# A350 NLG

Steering & Operating Noise

Liebherr-Aerospace

# INVESTIGATION AND ROOT CAUSE

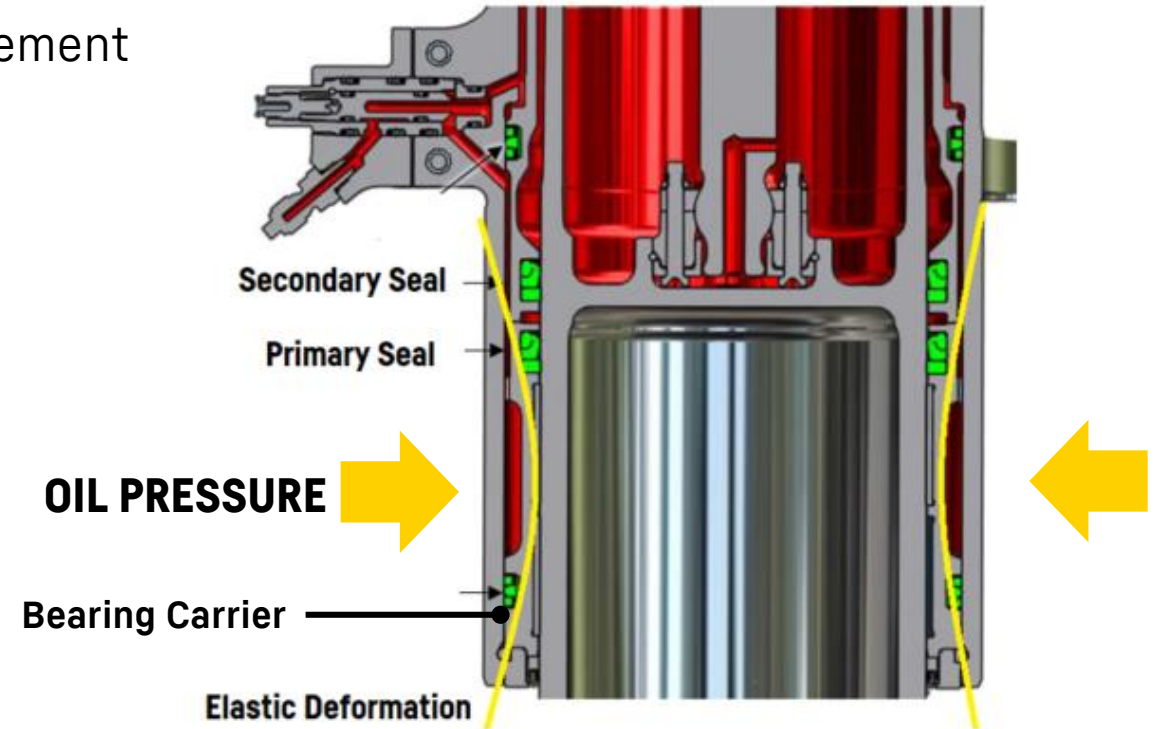
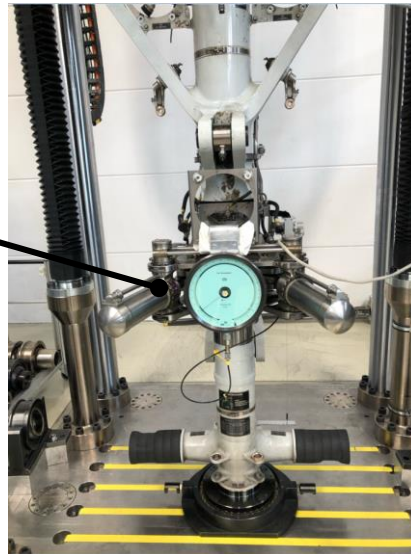
- No noise / no elastic deformation on bearing carrier (A/C unloaded)
- Elastic deformation on bearing carrier with high oil pressure (A/C loaded)
- Noise confirmed for the investigated NLGs @ LLI Test Rig
- Noise confirmed for turning and/or damping movement

## IN-SERVICE SOLUTION

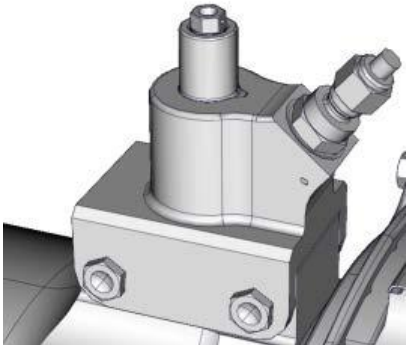
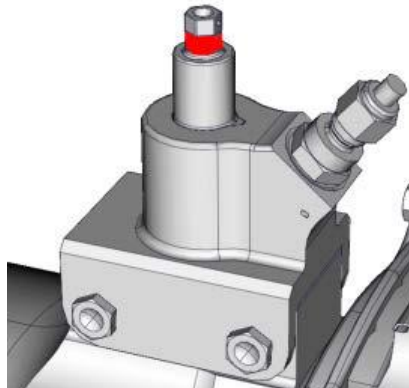
- Activation of secondary seal in weight off wheels conditions (on jacks) per MP Task **A350-A-32-21-73-02001-132A-A** , this restores nominal behavior.
- Ref. Airbus Technical Follow Up TFU No.: 32.21.00090

COV is NOT Activated = red mark is not visible

COV is Activated = red mark visible

# IN-SERVICE SOLUTION

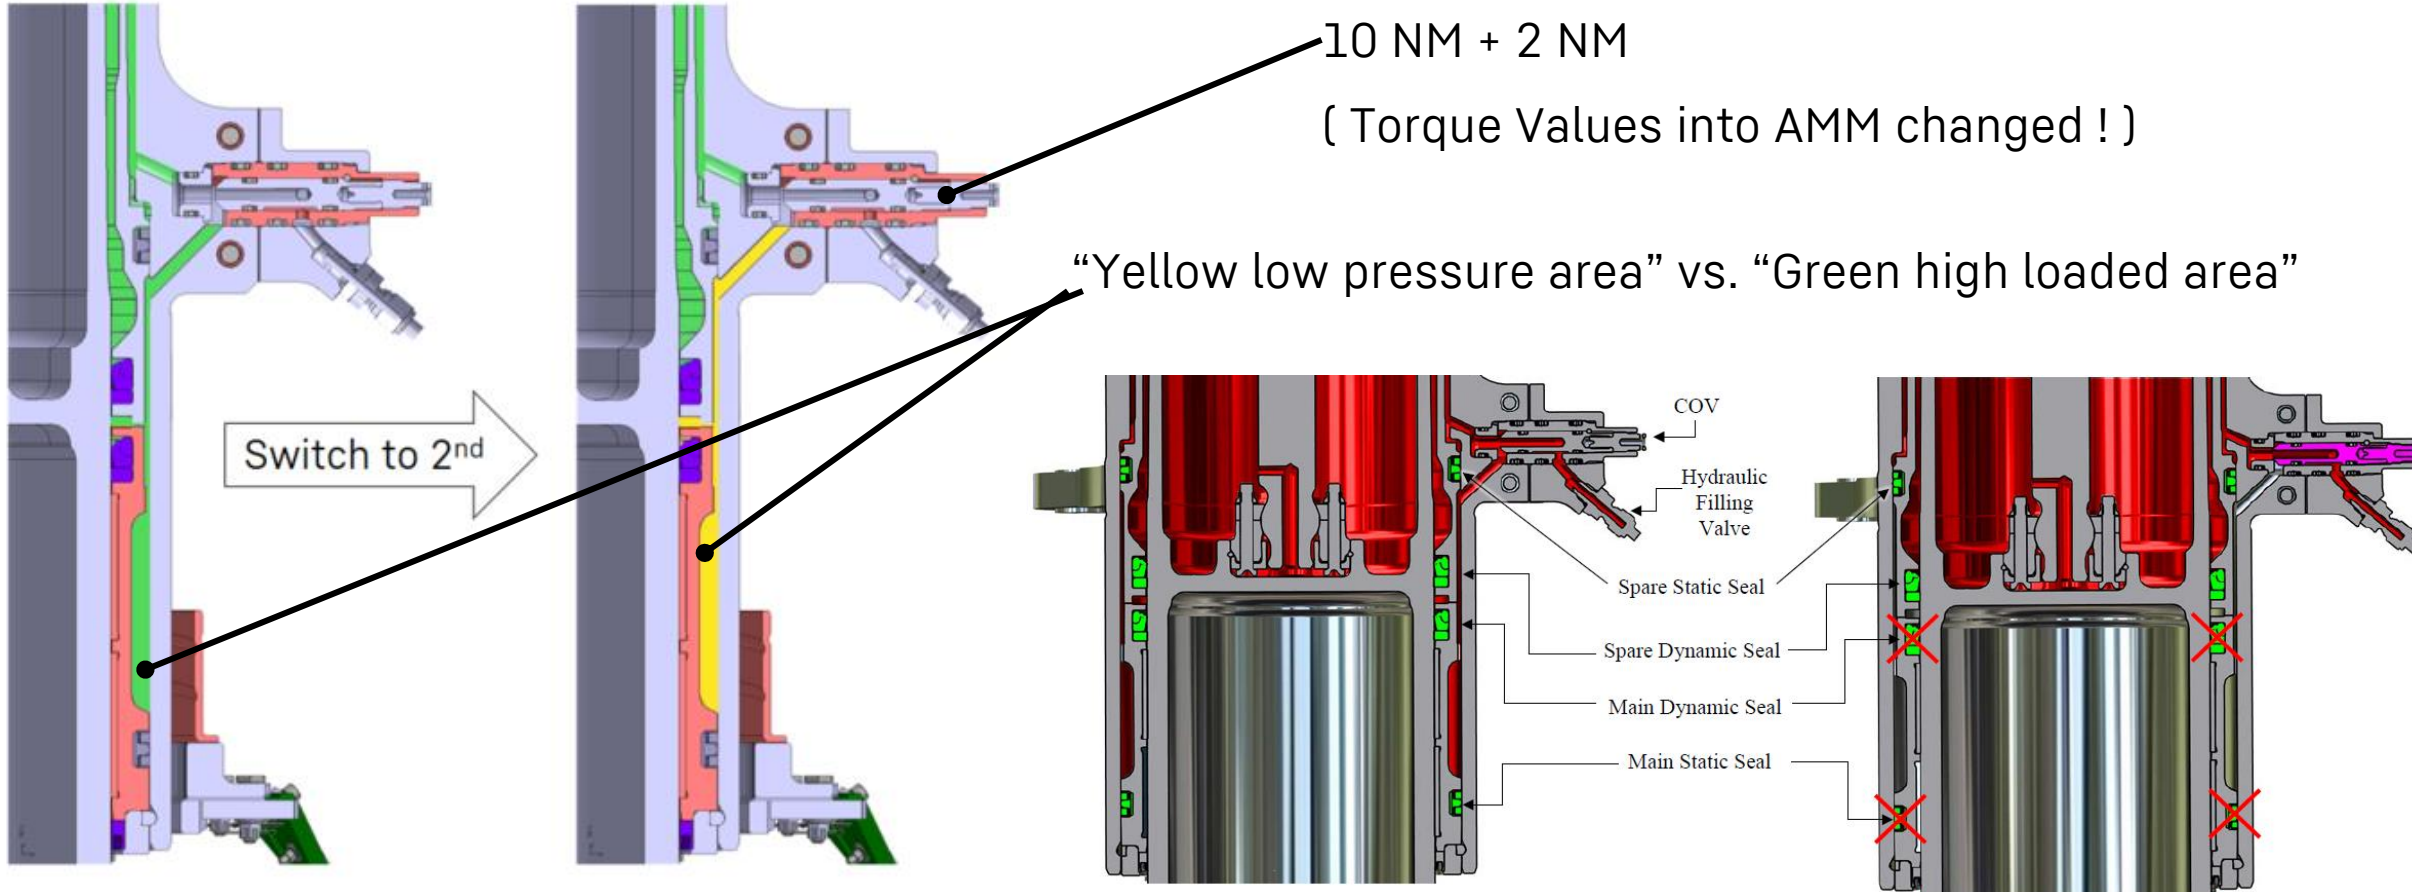
– **Switch to 2<sup>nd</sup> seal eliminates pressure effects**

“Yellow low pressure area” vs. “Green high loaded area”

10 NM + 2 NM

( Torque Values into AMM changed ! )

# FINAL SOLUTION

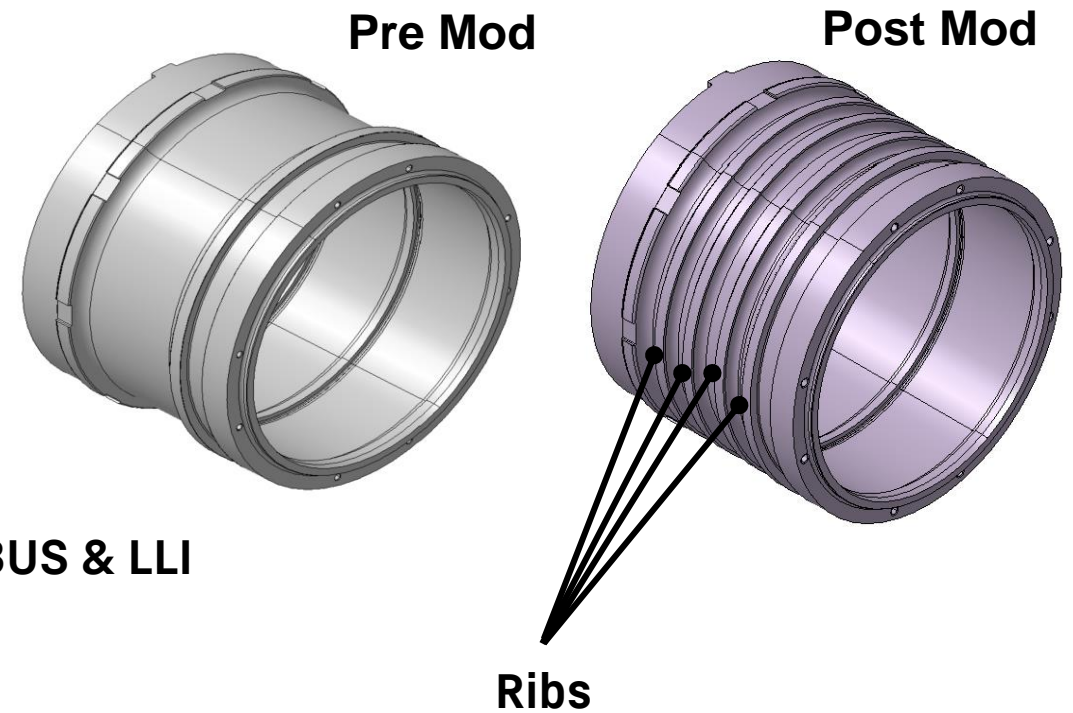
Modification of bearing carrier to minimize the load effect at “high compressions” SATs

- Change of bearing clearance (higher gap)
- Stiffening of bearing carrier (additional ribs)
- Material change for common gear carrier

**Modifications are currently under review between AIRBUS & LLI**
